**Economic and Social Council**

Economic Commission for Europe**Inland Transport Committee****World Forum for Harmonization of Vehicle Regulations****Working Party on Passive Safety****Seventy-second session**

UN Regulation No. 129 (Enhanced Child Restraint Systems)**Proposal for Supplement 9 to the 03 Series of Amendments to
UN Regulation No. 129 (Enhanced Child Restraint Systems)****Submitted by the expert from the European Association of Automotive
Suppliers ***

Figure 4
Arrangement for Testing a Forward-Facing Device

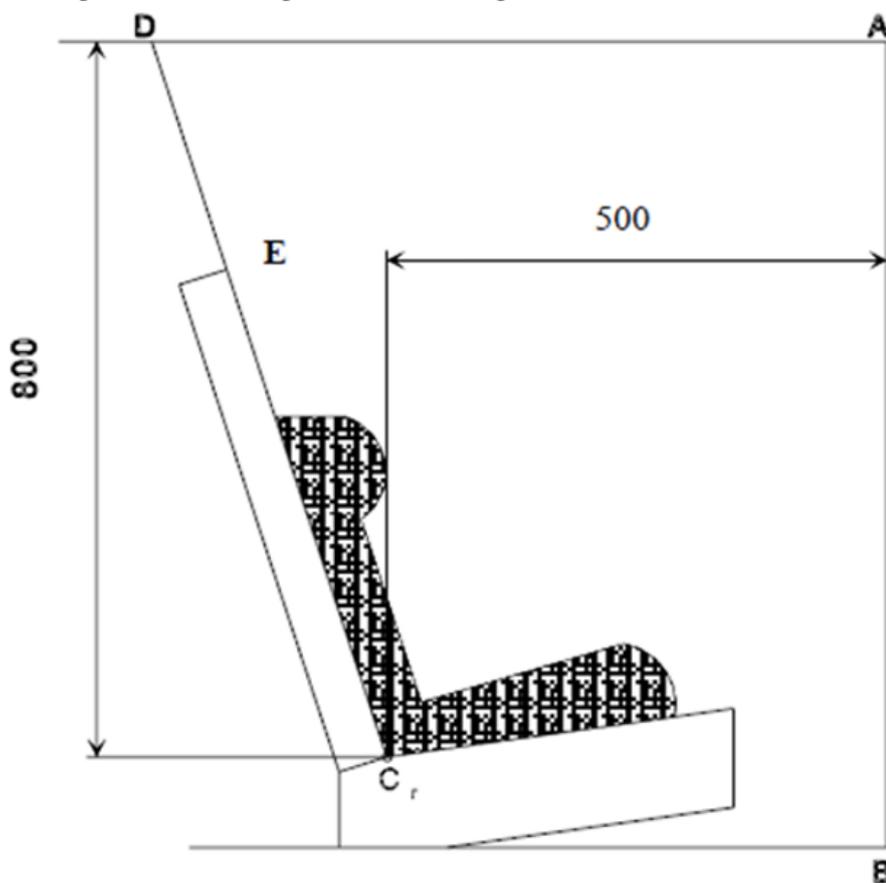
Integral Enhanced Child Restraints: No part of the head of the dummy shall pass beyond the planes BA, DA and DE as defined in Figure 4 below:

- (a) The value in relation to the BA plane is 500 mm; and
- (b) The value in relation to the DA plane is 800 mm, except when testing with the Q3 or Q6 dummy where the value is 840 mm; and
- (c) However, the head of the dummy may pass beyond the DE plane, if the head pad or the backrest part of the child restraint structure, which is behind the head of the dummy, at the point the head, passes the DE plane; and
- (d) In case of dummy contact with a rigid part of the test bench in the rebound phase, the head acceleration criterion during that contact shall not be considered.

When testing with the Q3 or Q6 dummy, the following applies:

The value in relation to the DA plane is 840 mm.

When testing with the Q6 dummy, the following applies:

The value in relation to the DA plane is 840 mm.

Since the vertical excursion of 840 mm is already well established for the Q10 in the forward-facing direction and Q3 and Q6 in the rearward-facing direction, it is very natural to also accept the vertical excursion of 840 mm for the Q3 and Q6 dummies in the forward-facing direction. This would harmonize the vertical excursion requirements to be consistent in all circumstances for the Q3, Q6 and Q10 dummies.

11. This amendment is not seen to have any negative consequences for the safety level of children, since the vertical excursion has existed at 840 mm in the Regulation for the relevant dummies.

12. Measurements of the space available in a sample of vehicles, show that the minimum vertical distance available from the Cr point in the vehicles was in most vehicles between 880 mm and 960 mm and in all cases more than 840 mm. Therefore, the space for the vertical excursion of 840mm is available in vehicles.

Figure 4
Arrangement for testing a forward-facing device

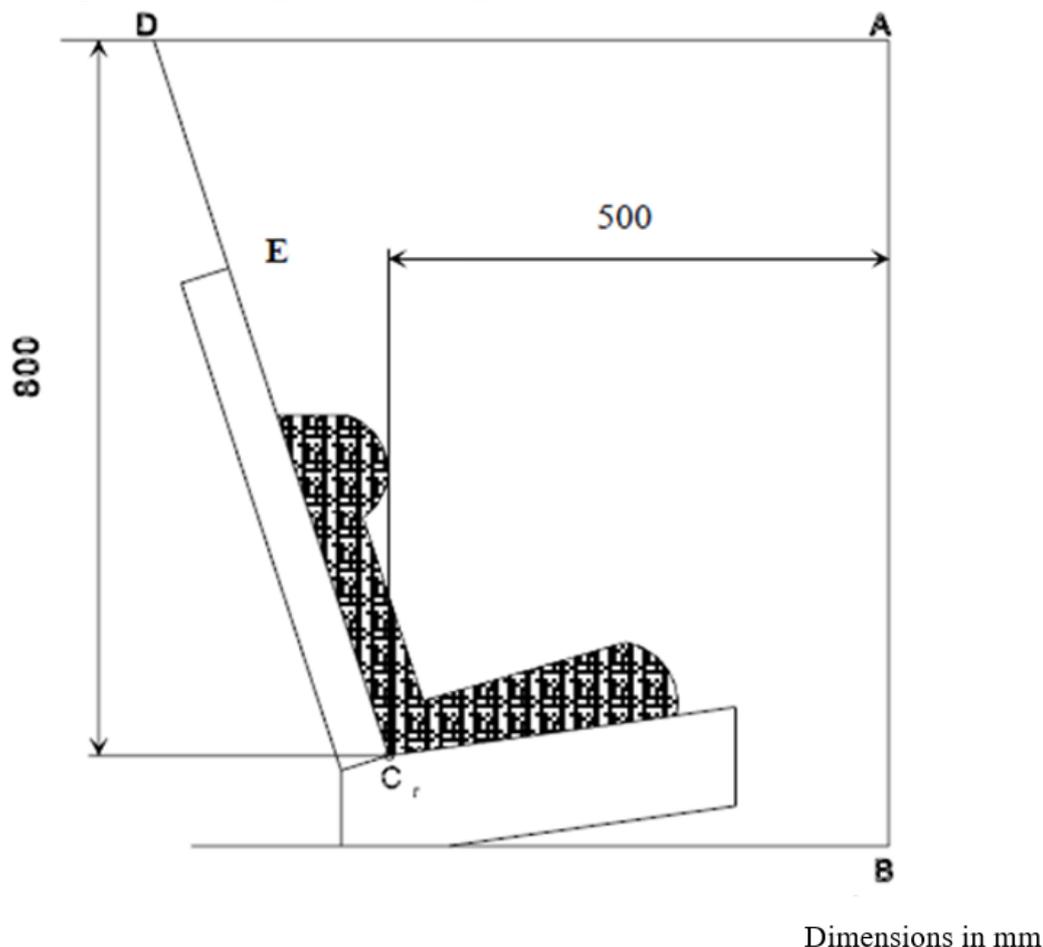
1. There is potential for a mistake in paragraph 6.6.4.4.1.1. if the legal text is strictly followed.

2. When document ECE/TRANS/WP.29/GRSP/2019/35 was adopted, then submitted to WP.29 as document ECE/TRANS/WP.29/2020/58, Supplement 04 to the 03 Series to UN Regulation No. 129, there was an instruction line and some "....." missing from that

document. The missing items indicated that new text was to be added after the existing text in paragraph 6.6.4.4.1.1.

3. If the instruction text and "....." remain missing, the legal text in ECE/TRANS/WP.29/2020/58 could be seen as a replacement of text for the entire of paragraph 6.6.4.4.1.1. This would lead to the deletion of requirements for head excursion, for integral Enhanced Child Restraints Systems (ECRS).

Figure 2

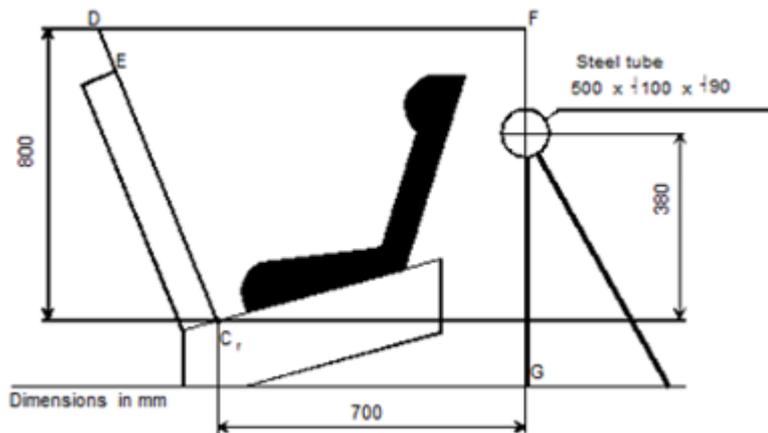
"6.6.4.1.2.1. Head excursion: no part of the head of the dummy shall pass beyond the planes FD, FG and DE, as shown in figure 2 below. This shall be judged up to 300 ms or the moment that the dummy has come to a definitive standstill whatever occurs first.

Except when testing using Q6 or Q3 dummy where the value in relation to the FD plane is 840 mm.
